**Re: Chevron Service Station #9-0917  
5820 Hopyard Road, Pleasanton, California**

TITLE: **PROPOSED SOIL BORING LOCATION MAP**

PREPARED FOR: **CHEVRON U.S.A. SERVICE STATION 9-0917**  
5280 Hopyard Road at Owens Drive  
Pleasanton, California

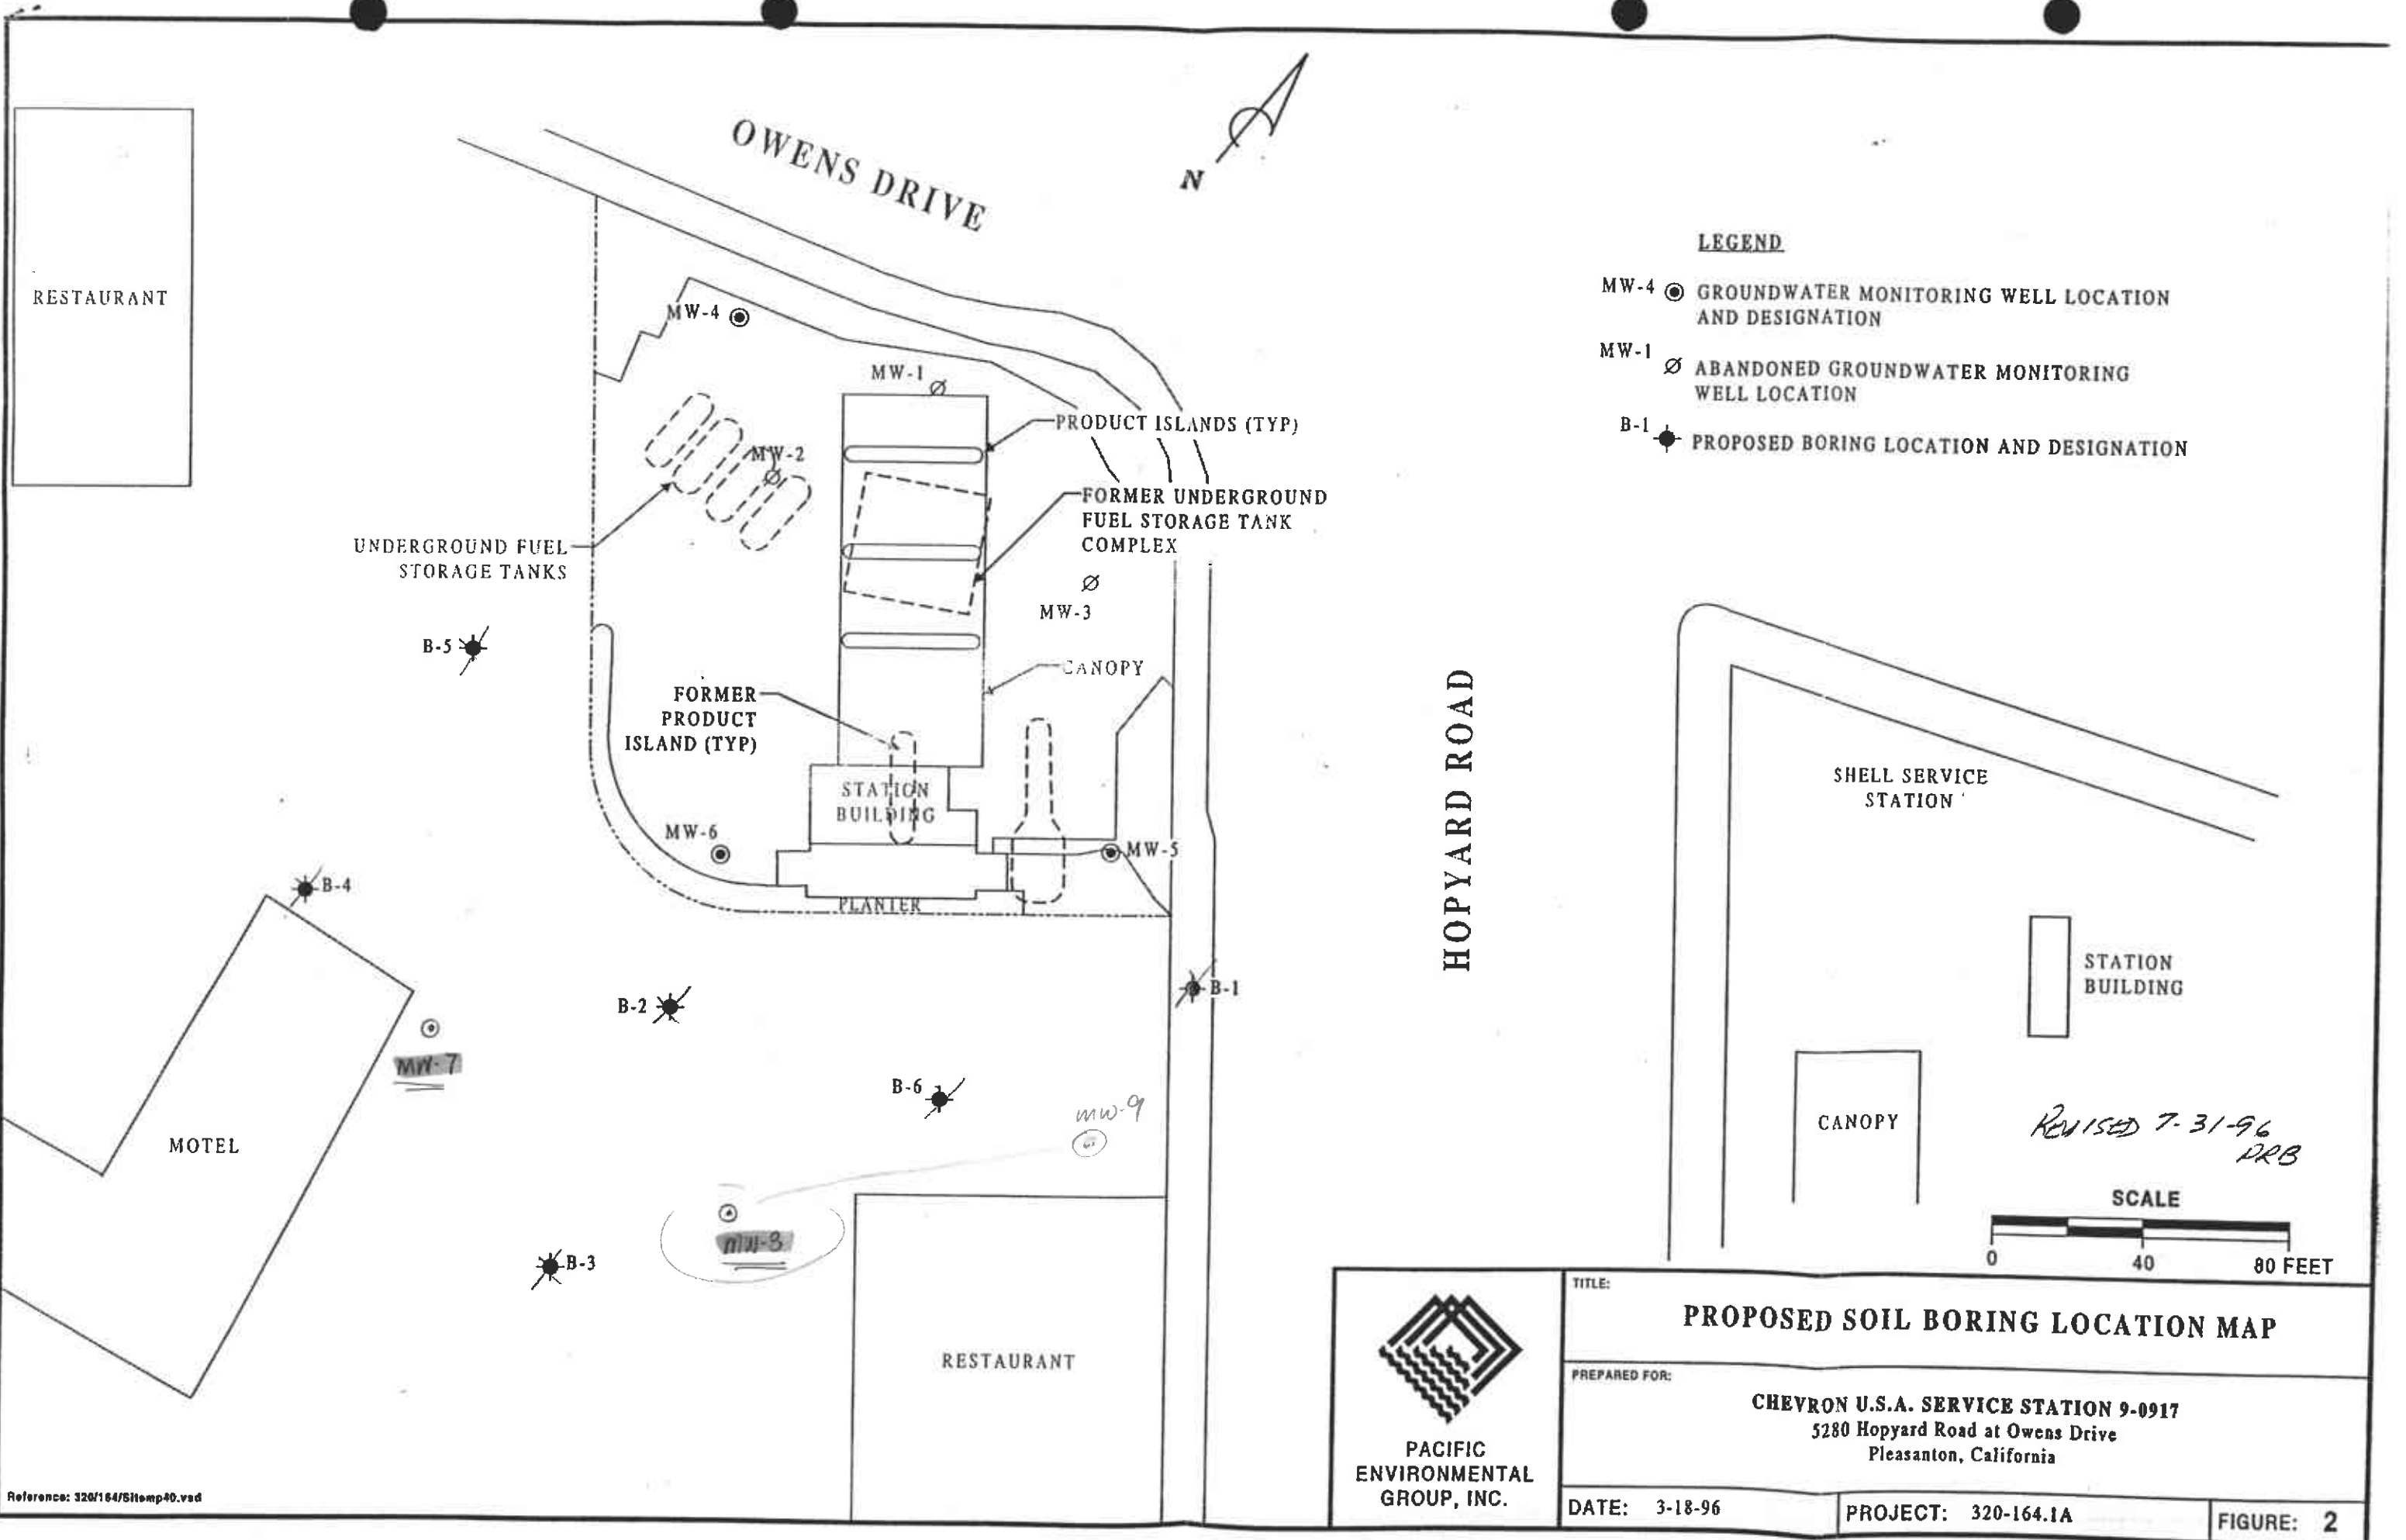
Per my conversation with you today, I am enclosing a revised site plan showing the elimination of six geoprobes and the installation of two monitoring wells. The original Work Plan showed 6 geoprobe locations that would be used to determine the location of future monitoring wells. I am requesting that you review and give consideration to installing the monitoring wells at this time, and eliminate the geoprobe phase.

The groundwater direction of flow appears to be southerly, even though the last quarterly report showed a northerly direction. Therefore, the monitoring wells (MW-7 and MW-8), that I propose to be installed at the site are downgradient of the on-site monitoring wells MW-5 and MW-6. Monitoring well MW-7 would be located midway between the geoprobes B-2 and B-4, and downgradient of MW-6. The geoprobes were located in a relatively downgradient direction from MW-6. Monitoring well MW-8 would be located midway between the geoprobes B-3 and B-6, and downgradient of MW-5. Again, the geoprobes were located in a relatively downgradient direction from MW-5. Geoprobe B-5 was located relatively downgradient of MW-4 which has been below method detection limits for BTEX constituents, therefore, the lateral extent of the dissolved petroleum hydrocarbon is known in this area. Geoprobe B-1 is located out of line of the downgradient flow from MW-5.

Installing the monitoring wells instead of the geoprobes should give us the same data as we would receive from the geoprobes, and we would not interfere with the businesses in the area twice. There would be no change to the soil and water sampling analysis as noted in the Work Plan. If you agree to this approach, I will advise our consultant Pacific Environmental Group, Inc. and have them submit a revised Work Plan for your approval. Any questions, call me at (510) 842-9136.
